PRODUCT BULLETIN # 20205Generic Copy

Issue Date: 27-Aug-2013**TITLE:** LMV358DMR2G Bond Pad structure change**PROPOSED FIRST SHIP DATE:** 27-Nov-2013**AFFECTED CHANGE CATEGORY(S):** Device Ordering Code**FOR ANY QUESTIONS CONCERNING THIS NOTIFICATION:**Contact your local ON Semiconductor sales office or <Shannon.riggs@onsemi.com>**NOTIFICATION TYPE:**ON Semiconductor considers this change approved unless specific conditions of acceptance are provided in writing. To do so, contact <quality@onsemi.com>.**DESCRIPTION AND PURPOSE:**

Figure 1: Cross Section representation of bond pad stack.
Original design (left), modified design (right).

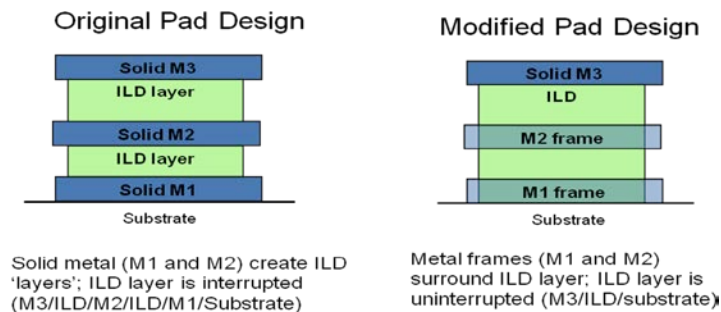
This product bulletin is to announce the completion of the qualification of the bond pad structure change on LMV358DMR2G. The change in bond pad structure is diagrammed below, and was determined necessary in order to eliminate the risk of bond pad damage during wire bond, and is the resulting action of EFAR 424841.

There are no changes to the product datasheet as a result of the change in bond pad structure (http://www.onsemi.com/pub_link/Collateral/LMV321-LMV358-LMV324-D.PDF). The new pad structure has successfully passed the required reliability testing and has been released for production manufacturing as of April 2013.
